PLAN OF PROPOSED IMPROVEMENT

NINTH ADDITION TO BLACKHAWK SUBDIVISION - PLAT AND REZONE

CITY PROJECT NO. 11943

PLAN AND PROFILE SANDHILL ROAD CITY OF MADISON

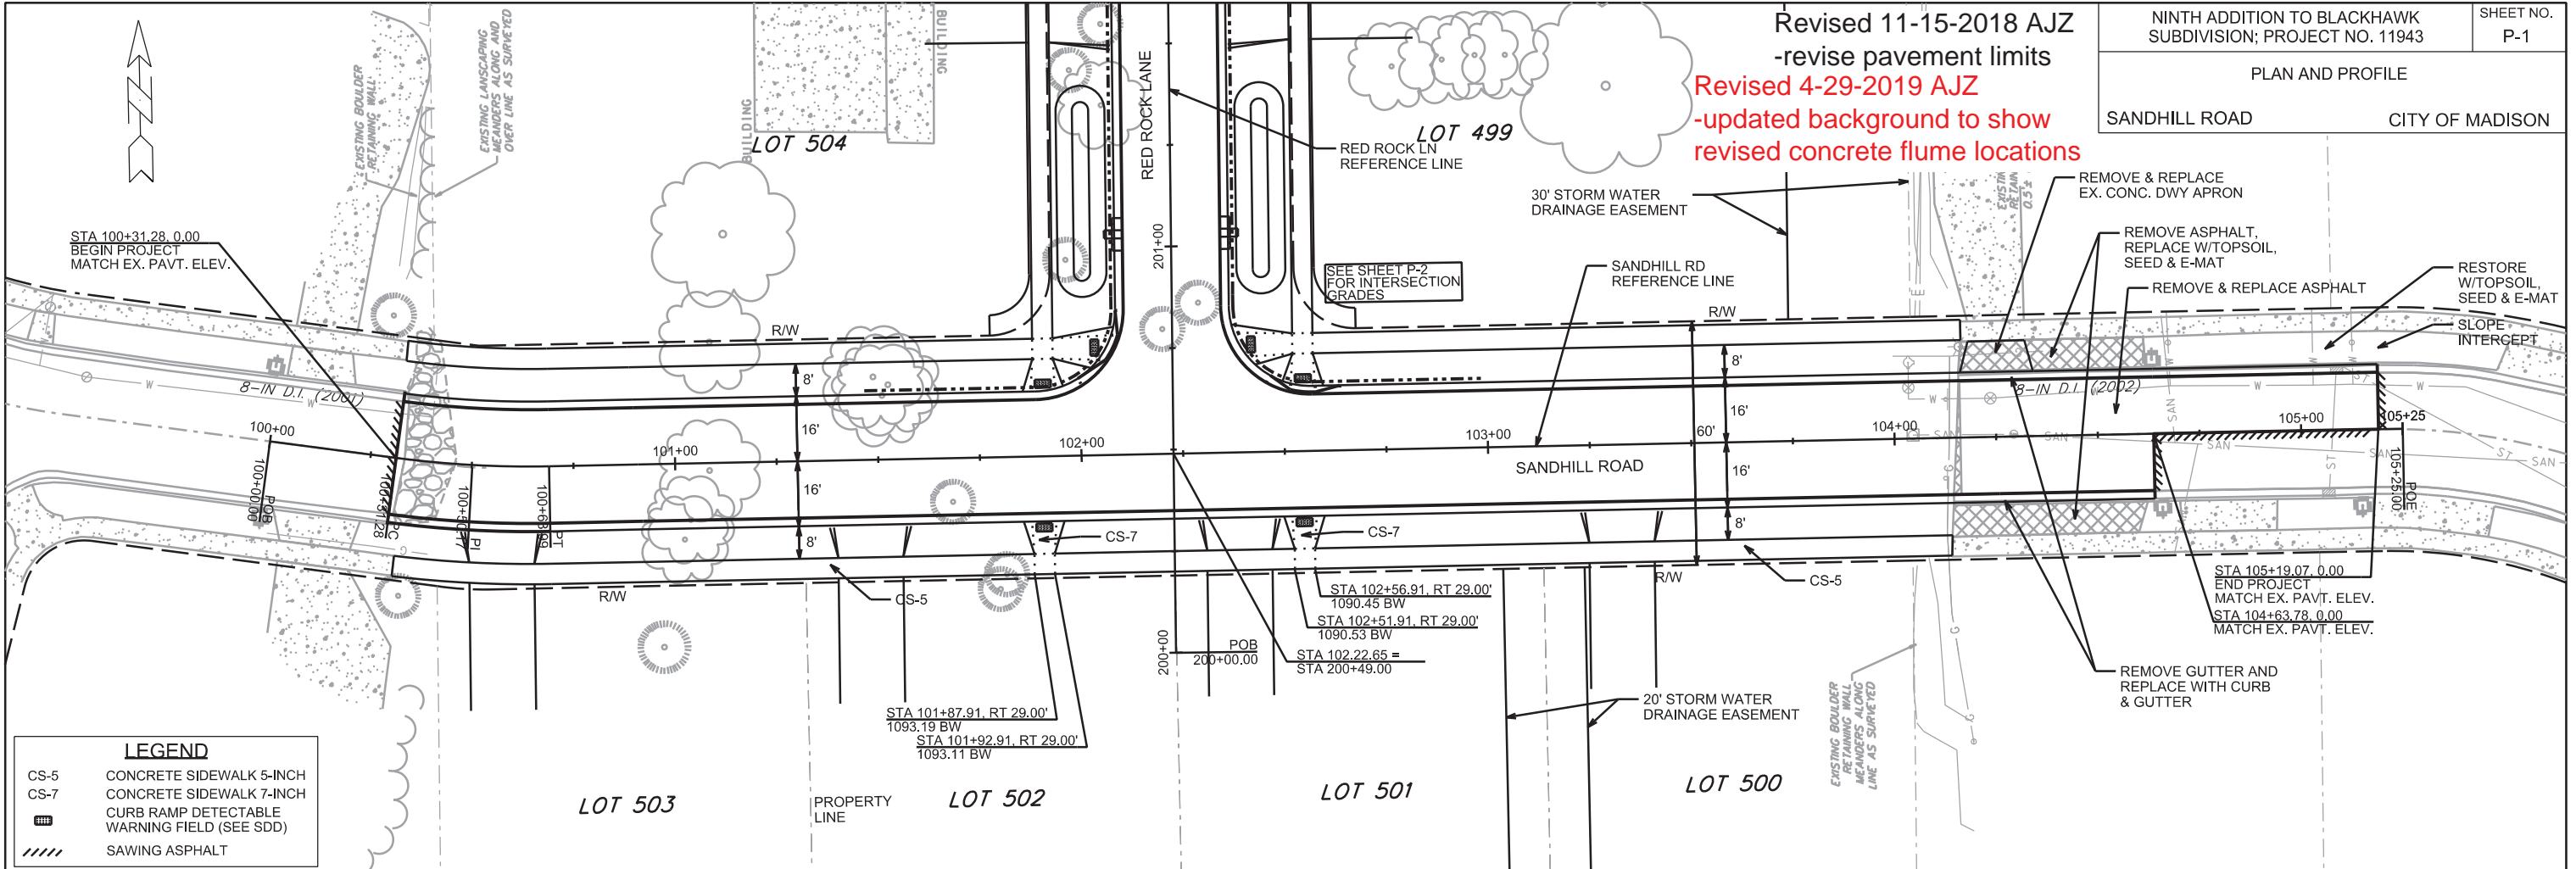
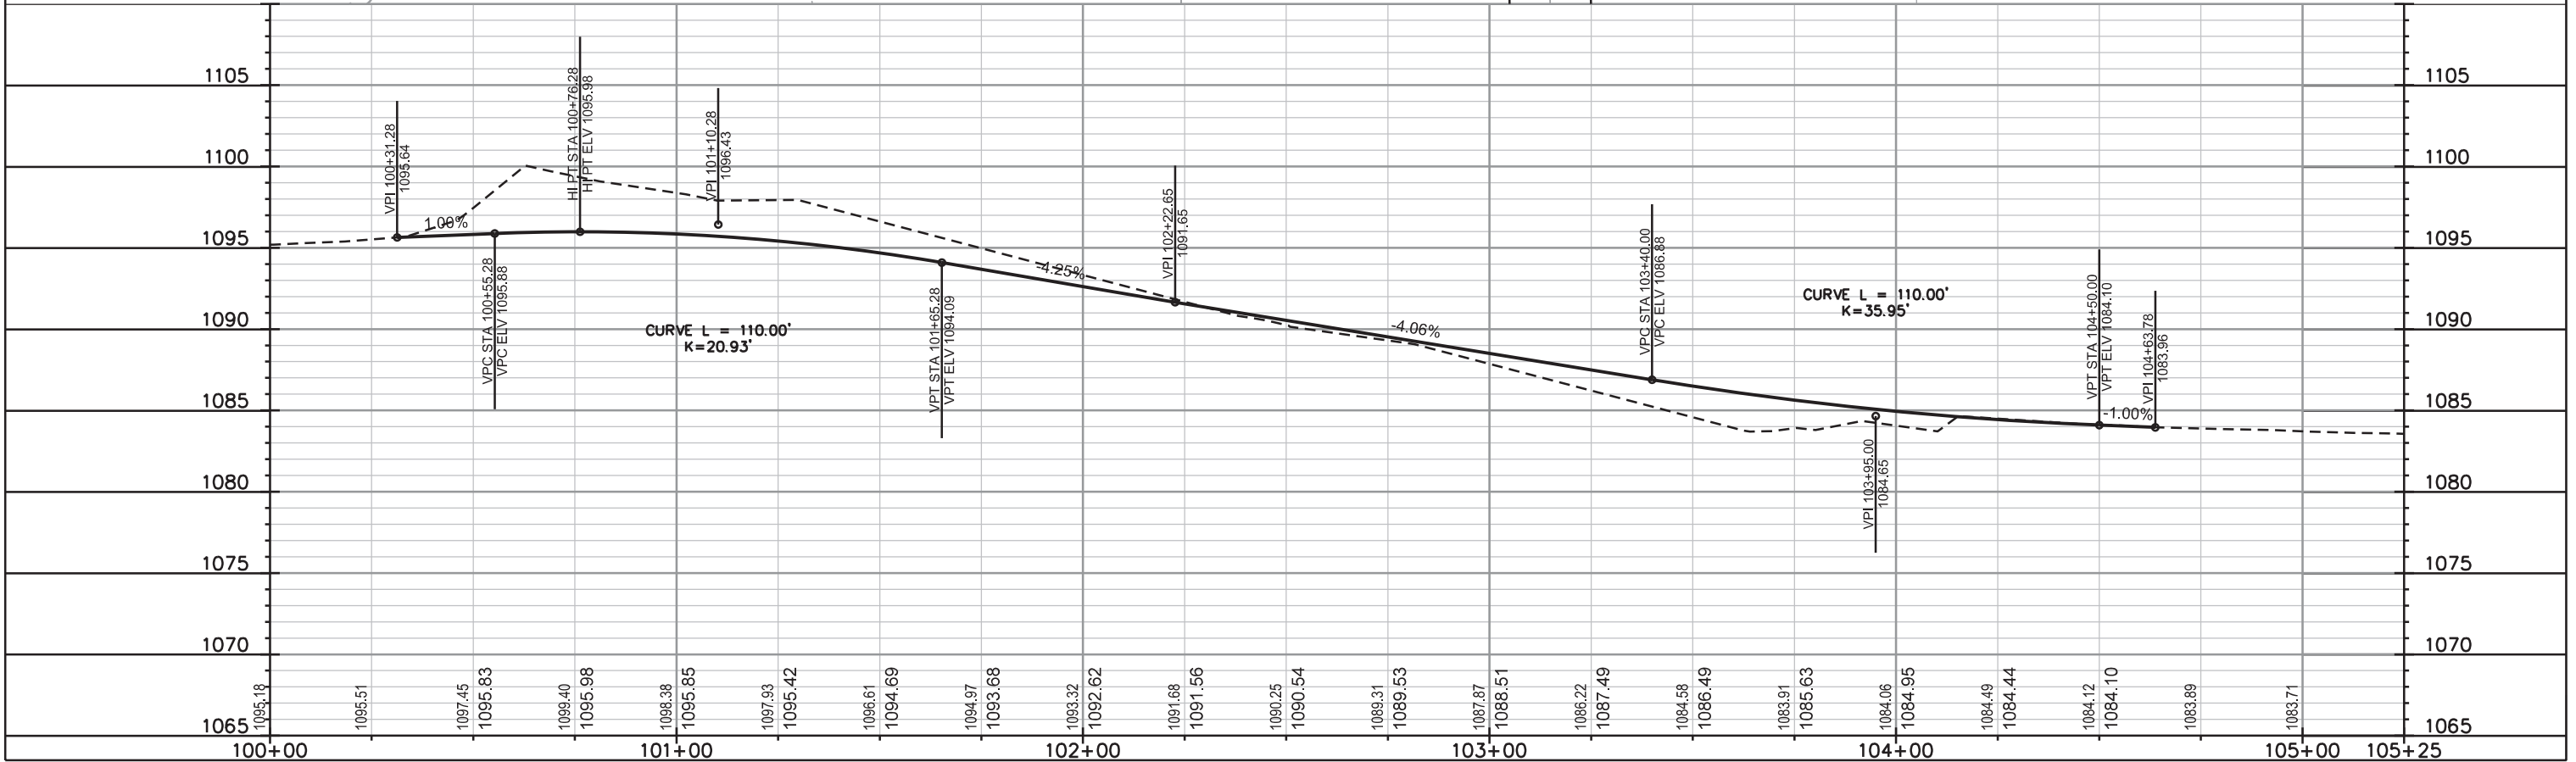
Revised 11-15-2018 AJZ
 -revise pavement limits
 Revised 4-29-2019 AJZ
 -updated background to show revised concrete flume locations

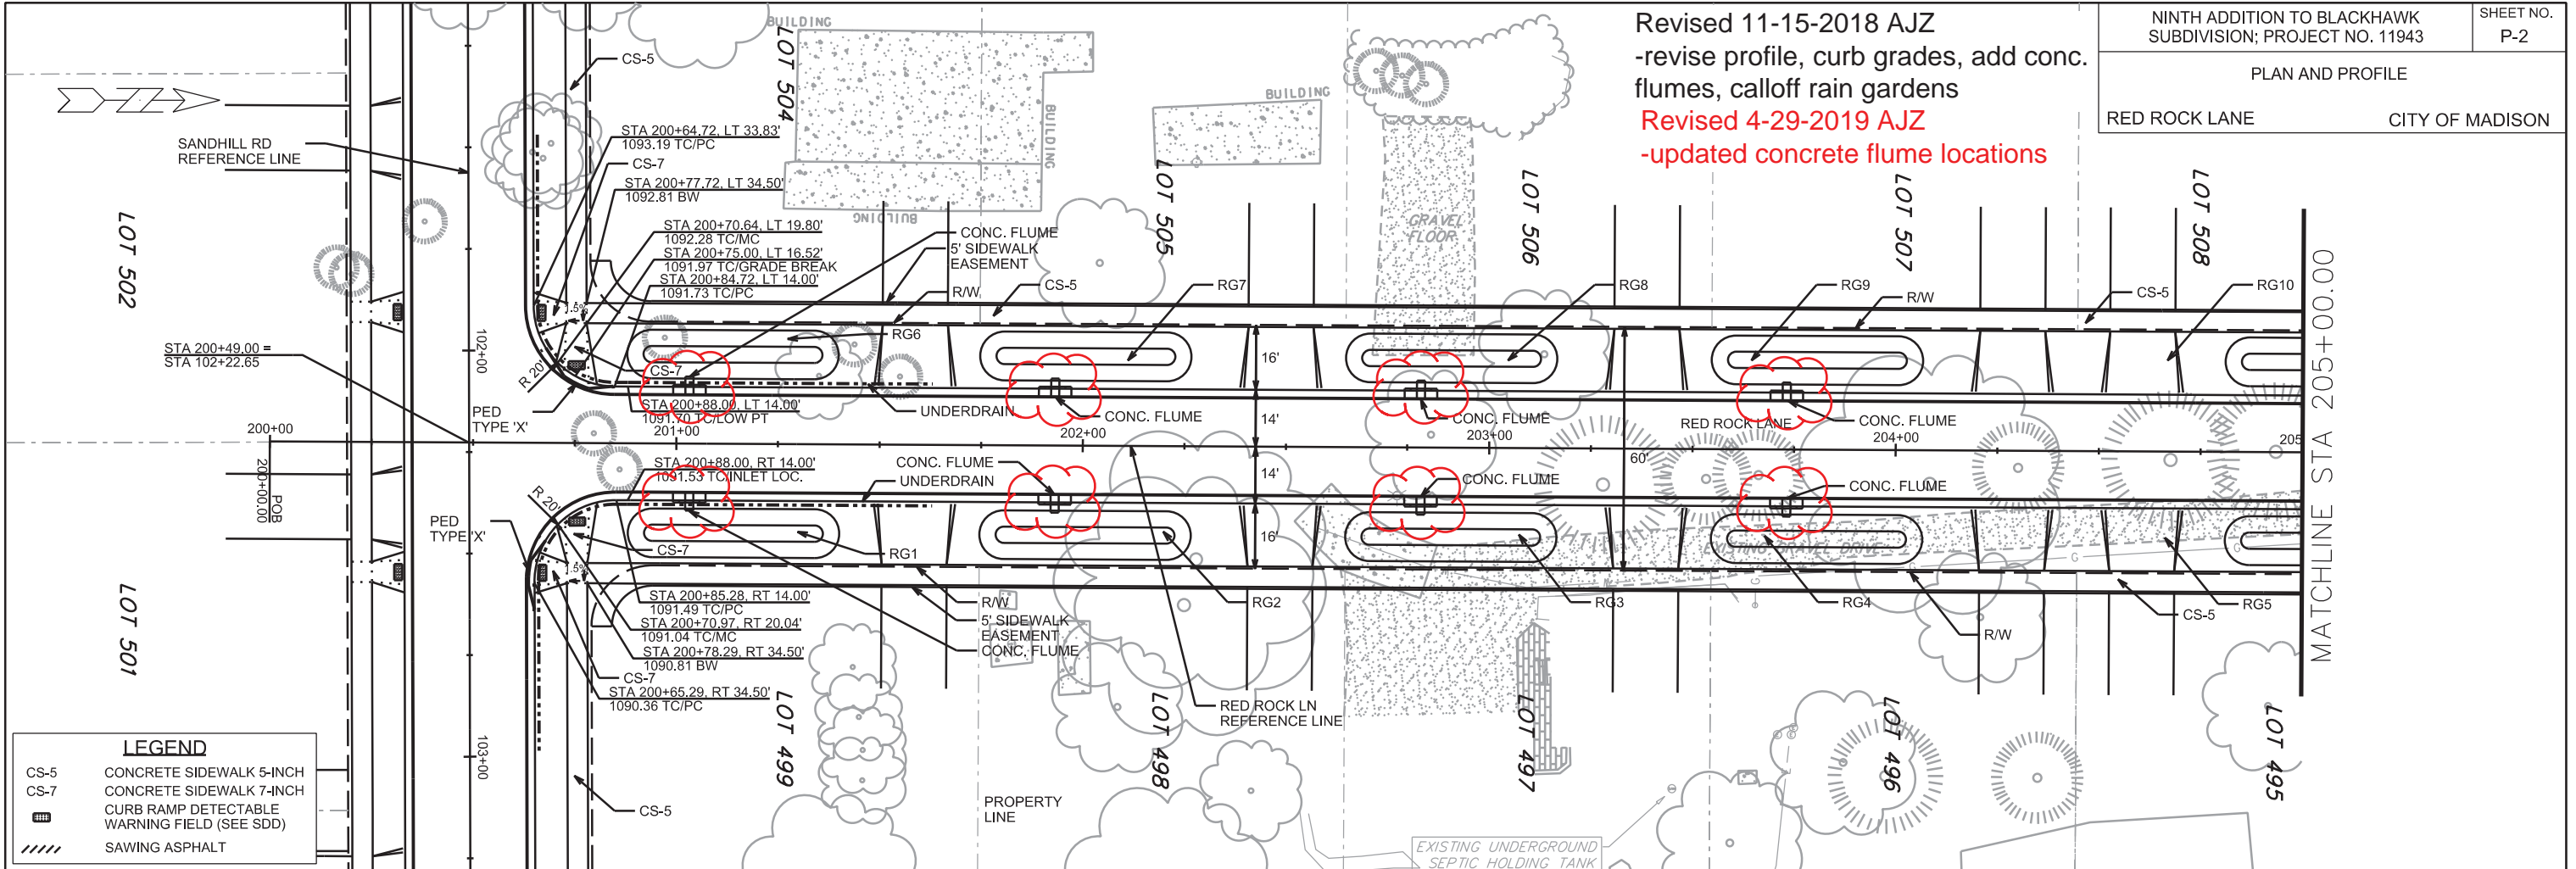
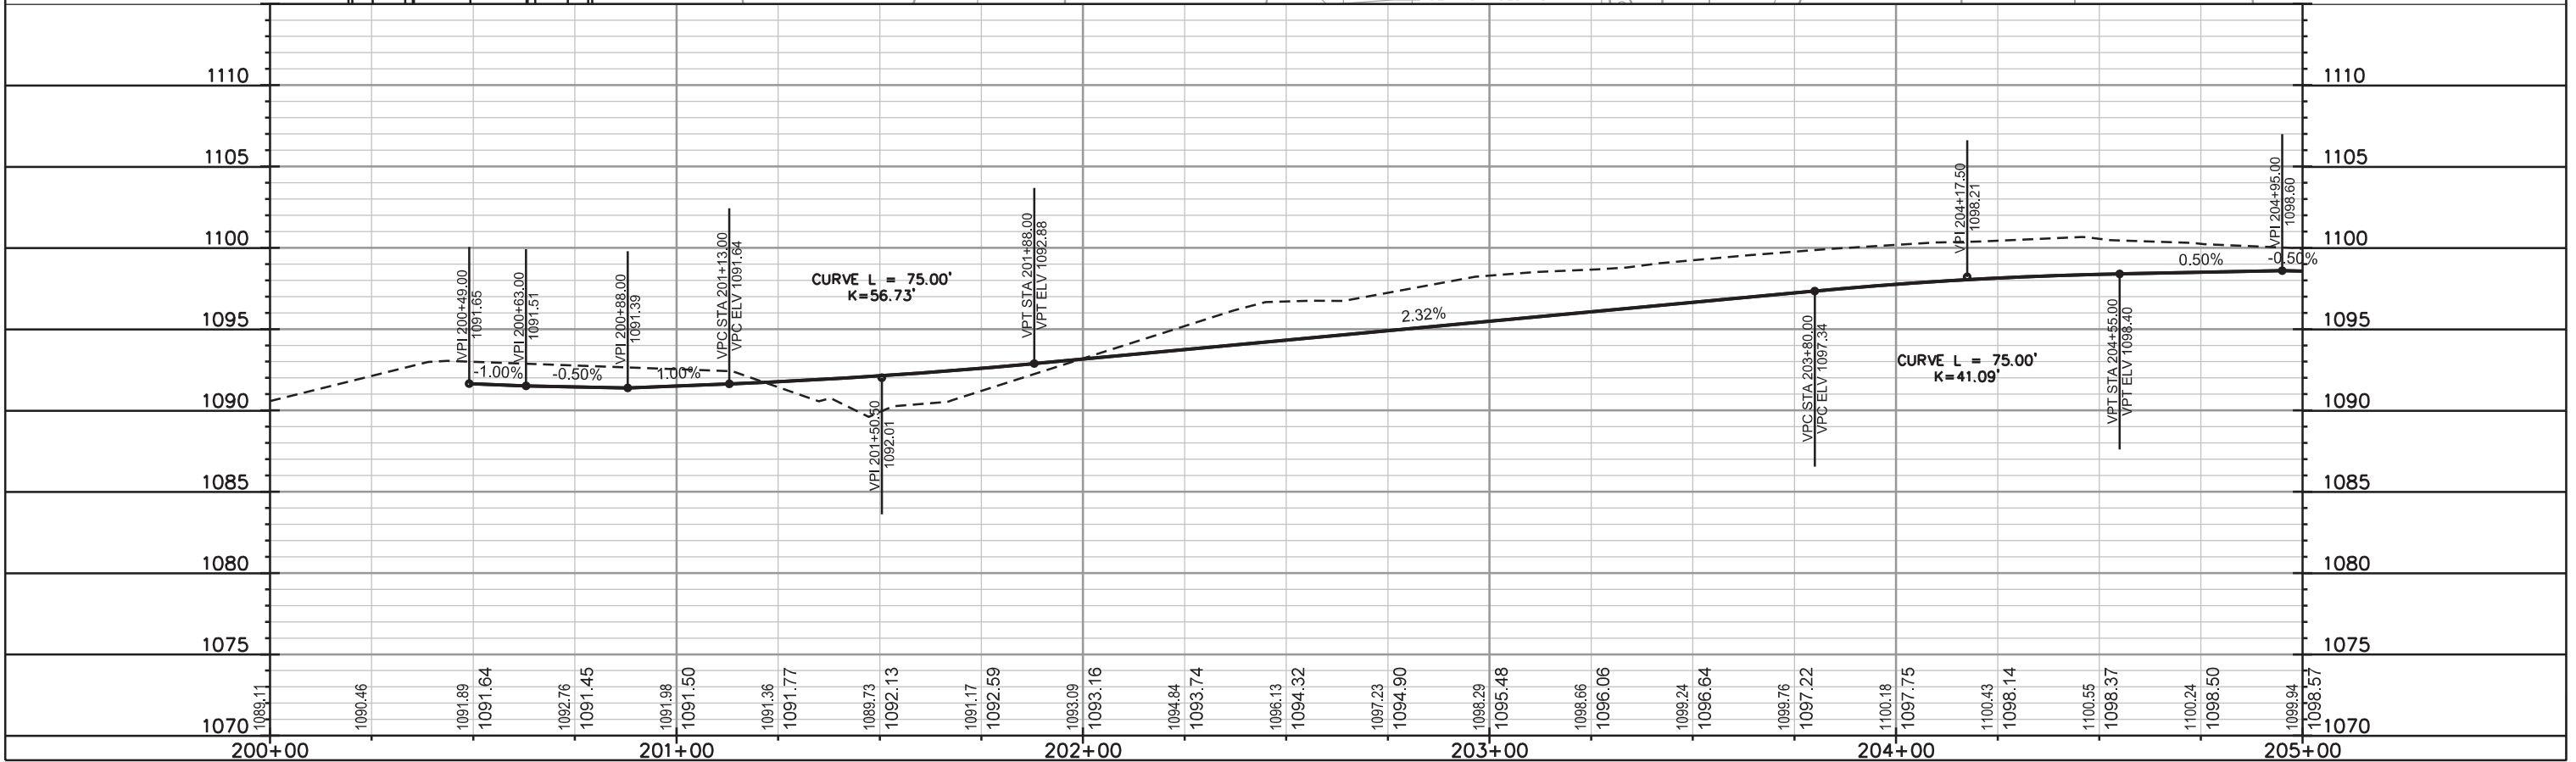
Revised 11-15-2018 AJZ
-revise profile, curb grades, add conc. flumes, calloff rain gardens
Revised 4-29-2019 AJZ
-updated concrete flume locations

PLAN AND PROFILE
RED ROCK LANE CITY OF MADISON

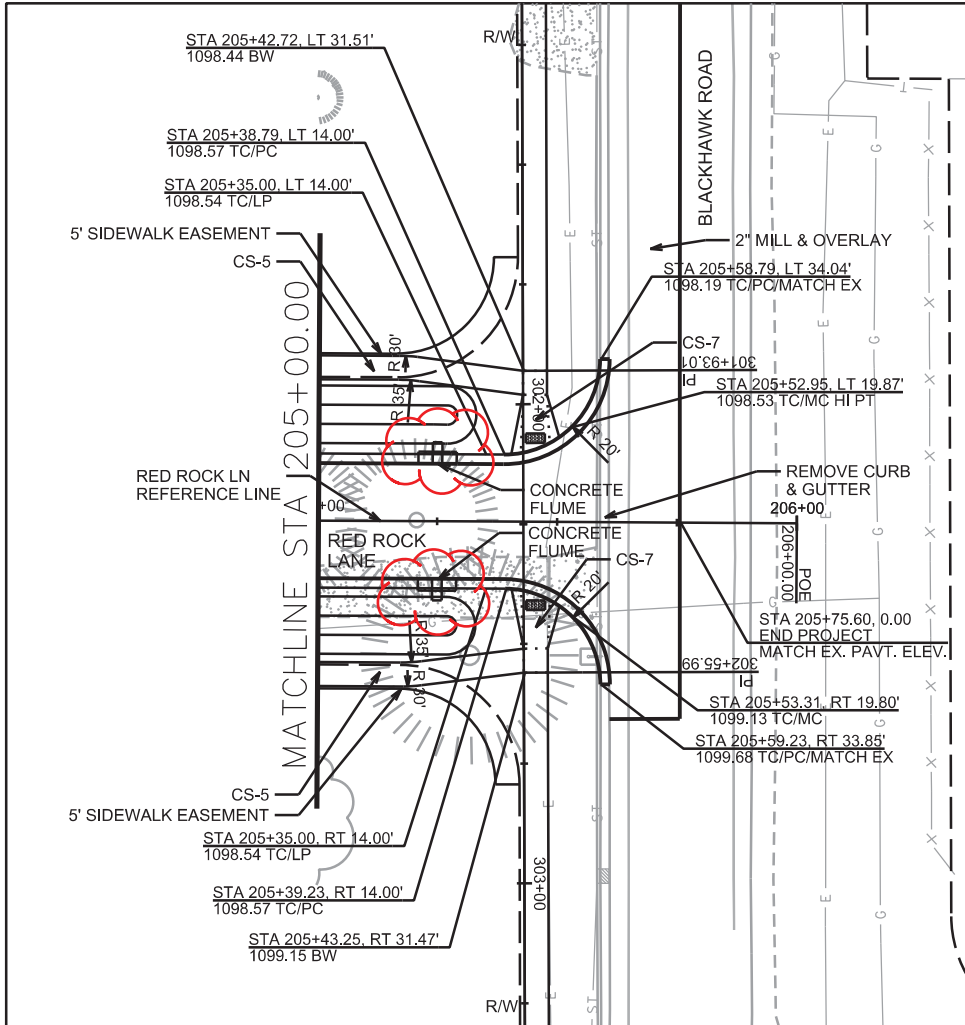
Revised 4-29-2019 AJZ
-updated concrete flume locations
